Link Management Parameters for 10 Mb/s Operation and Associated Power Delivery over a Single Balance

CI 45 SC 45.2.7.25.1 P 58 L 35 # i-230

[6] Insert a new Figure 145-6 shown below (view using a non-proportional font such as courier), renumbering the following figures as required.

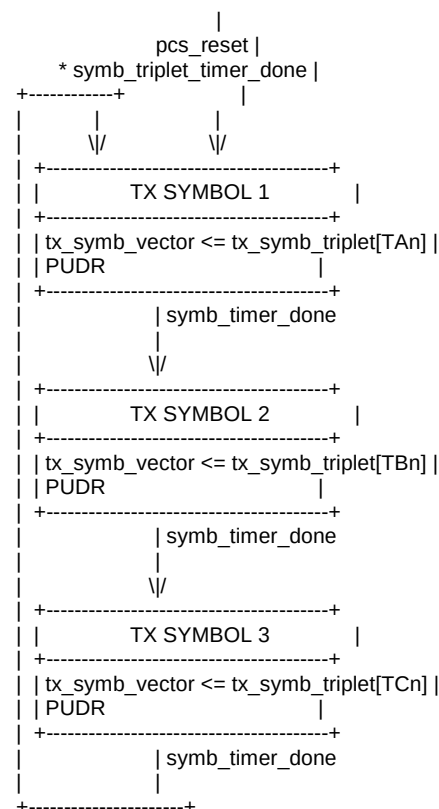
Is it correct that 'The PCS Transmit function shall conform to the PCS Transmit state diagram in Figure 146-5 ...' and that 'In each symbol period, PCS Transmit generates a symbol An provided to the PMA ...'? The PCS Transmit state diagram in Figure 146-5 changes state based on STD being true, with STD being an alias for symb_triplet_timer_done, and the output of the PCS Transmit state diagram is tx_symb_triplet which is defined in subclause 146.3.3.1.1 'Variables' as 'A triplet of ternary symbols generated by the PCS Transmit function after 4B3T encoding.'

I think the problem is that there is another function within the PCS Transmit function that is missing from the PCS Transmit state diagram in Figure 146-5, the 'multiplexor' shown in Figure 146-6 'PCS transmit symbol generation'. This 'multiplexor' function operates at the symbol clock rate and serialises the tx_symb_triplet code-groups output by the PCS Transmit state diagram into individual symbols.

This may also explain when subclause 146.3.3.1.3 'Timers' defines the symb_timer that is not used in the PCS Transmit state diagram in Figure 146-5.

[4] Add a new subclause 146.3.3.2.2 titled 'Timers'. Move the symb_timer definition from subclause 146.3.3.1.3 Timers to this new subclause.

[5] Add a new subclause 146.3.3.2.4 'Abbreviations' that reads:

[7] Add text to subclause 146.3.3 'PCS Transmit' that reads 'The PCS Transmit function shall conform to the PCS Transmit state diagram in in Figure 146-5 and the PCS Transmit multiplexor state diagram in 146-6, and their associated state variables, functions, timers, and messages.'
